**Economic Commission for Europe****Inland Transport Committee****World Forum for Harmonization of Vehicle Regulations****188th session**

**1958 Agreement:****Consideration of draft amendments to existing UN Regulations submitted by GRSG****Proposal for the 04 series of amendments to UN Regulation  
No. 34 (Prevention of fire risk)****Submitted by the Working Party on General Safety Provisions \***

Model A

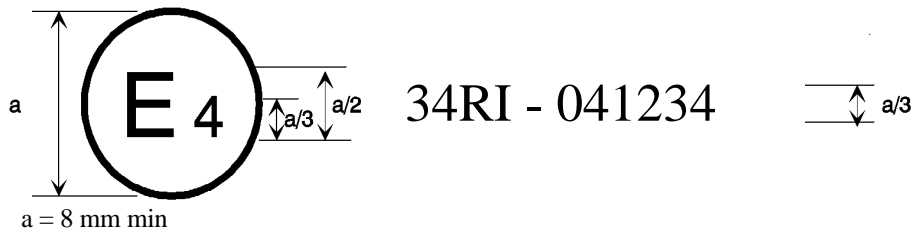
Annex 2, amend to read (footnote unchanged):

The above approval mark affixed to a vehicle shows that the type concerned was approved in the Netherlands (E4) pursuant to Part I of UN Regulation No. 34 under approval No. 041234. The first two digits (04) of the approval number indicate that the approval was granted in accordance with the requirements of UN Regulation No. 34 as amended by the 04 series of amendments."

Model E

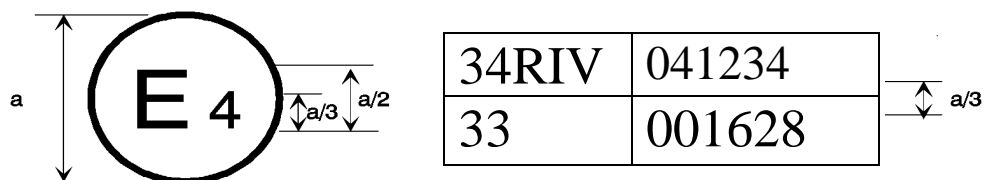
The above approval mark affixed to a vehicle shows that the type concerned was approved in the Netherlands (E4) pursuant to UN Regulations Nos. 34 Part IV and 33.\* The approval numbers indicated that, at the date when the respective approvals were given, UN Regulation No. 34 included the 04 series of amendments and UN Regulation No. 33 was still in its original form."
